Australian Turf Club Royal Randwick Racecourse-Hotel Response to Submissions

Prepared for the Australian Turf Club • November 2012

This report has been prepared in response to the letter from the Department of Planning and Infrastructure (DPI) dated 17 September 2012 requesting a Response to Submissions Report to be prepared for SSD 5002-2011. The letter requested the Proponent's Response to Submissions respond to specific issues raised by the DPI and other stakeholders during the assessment and consultation process of the Environmental Impact Statement (EIS) of the Proposal for the development of the land at the Royal Randwick Racecourse (RRR) Alison Road, Randwick.

FIGURE 1 – INTERNAL COMFORT – VISUAL OUTLOOK

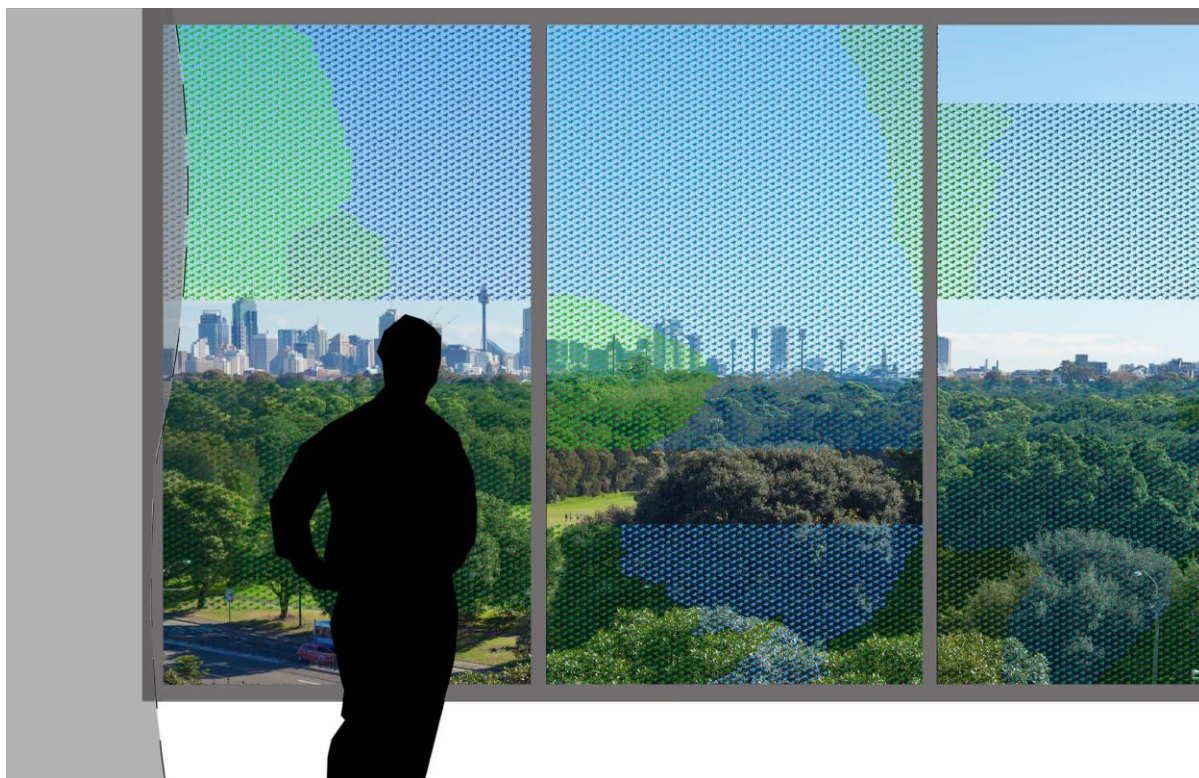
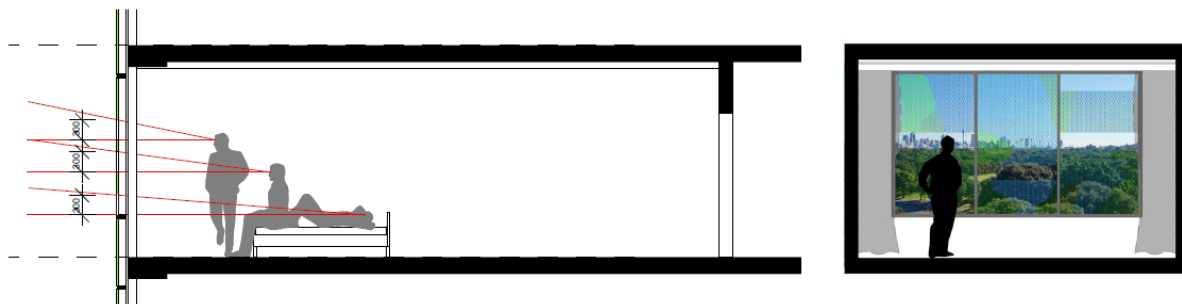
In response to concerns raised in respect of internal comfort for guests, the proponent provides the following response in relation to perceived visual outlook to the north of the site:

- In relation to the view experienced by hotel guests when looking north, the façade design proposes that portions of the coloured pixels shall be removed from the hotel room window so that at all 3 viewing positions (lying, sitting and standing) there is some section of clear glass and views to the park. **(Figure 4)**
- The proposed removal of these pixels incorporated within the abstract imagery will not detract from the overall external appearance or design quality of the proposed north facing façade.
- The lower building is a highly transparent glass volume and maintains a strong connection to the northerly aspect allowing views and light in and out, and through this space.
- The hotel entry is a highly visible 2 storey volume opening out to Alison Road providing expansive views through the building to the track beyond.

Figure 1 demonstrates the removal of pixels and how it achieves clear visibility from the inside to the external surrounds.

FIGURE 2 – DAYLIGHT PENETRATION TO NORTH FACING (WSP)

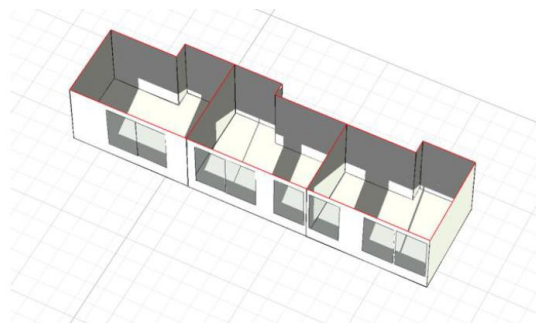
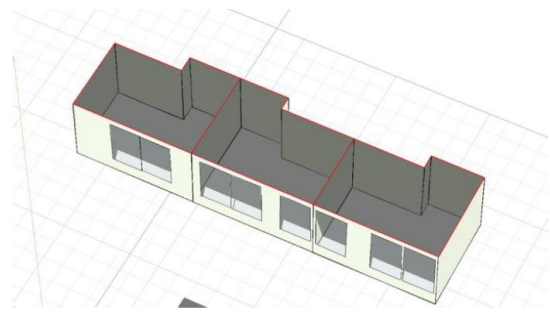
Figures 2 demonstrate the daylight penetration to the north facing hotel bedrooms and living areas. It can be seen that good daylight penetration levels are received in the winter months whilst nominal daylight penetration levels are received in the summer months. The levels indicated represent good conditions for thermal comfort.

FIGURE 5 – EXISTING DARLEY ROAD STABLING ARRANGEMENT

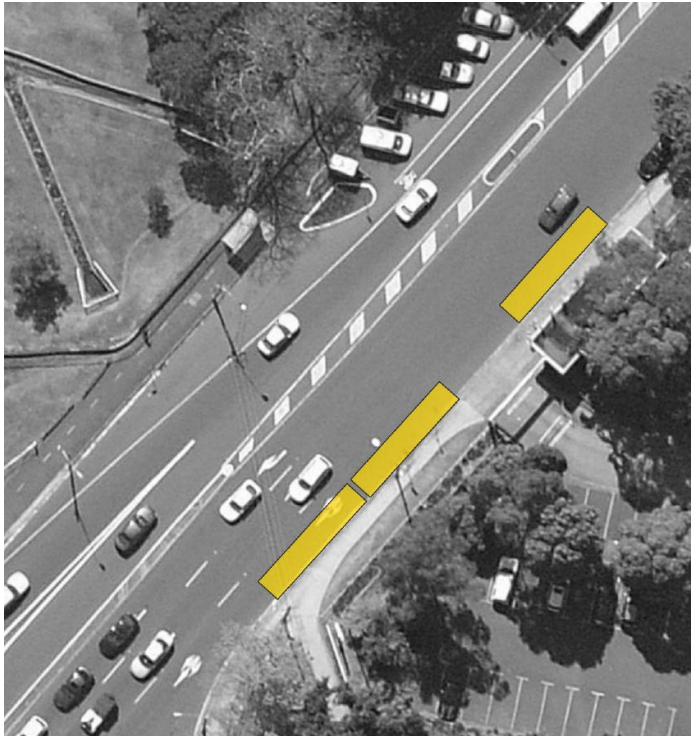
- Darley Road currently provides stabling facilities for up to three buses (refer to Figure 5) at any given time prior to receiving patrons leaving the RRR.

FIGURE 7 – PROPOSED ANZAC PARADE STAGING AREA

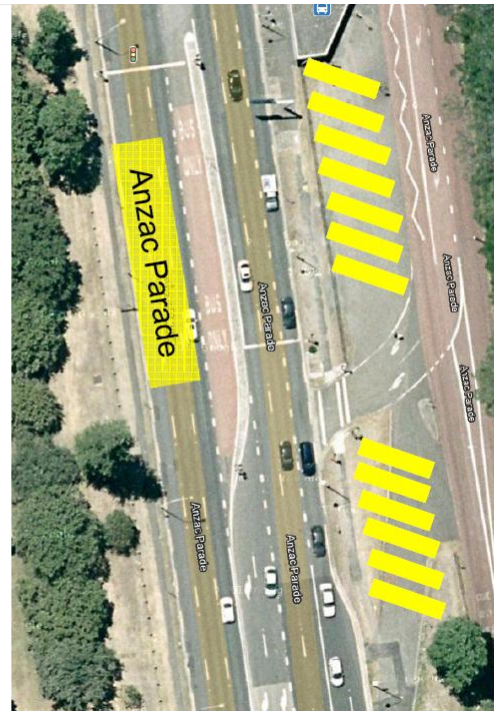
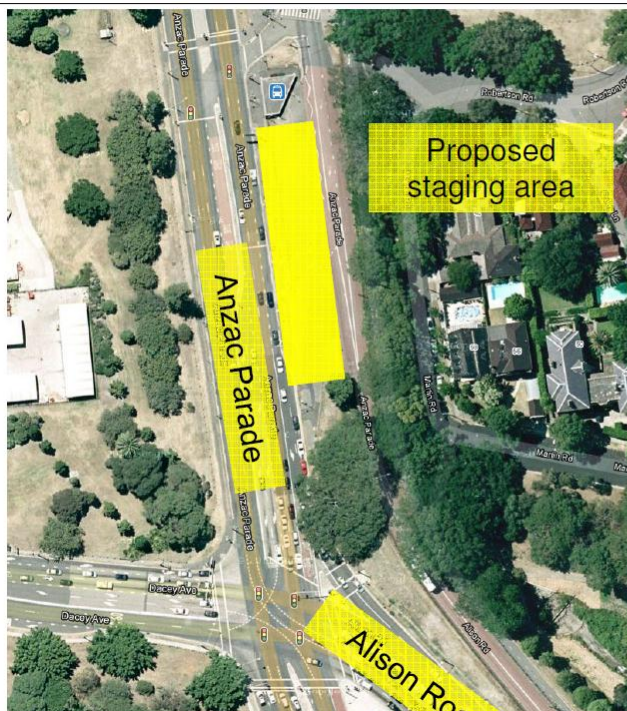
As an improvement to the current bus staging area in Darley Road, the proponent has identified a new staging area within the busway along Anzac Parade / Centennial Park (refer to Figure 7 below). This area is currently underutilised and has the ability to stable up to 13 buses without impacting the road network.

This arrangement will have a positive impact on the surrounding road network on major event days, as it will:

- Remove the need to stable buses on Darley Road.
- Reduce congestion and increase the capacity for effective use of the road on major event days for patron set down areas.
- Reduce the imposition on the large amount of vehicles using the roads in the area for weekend sport and access to Centennial Park.
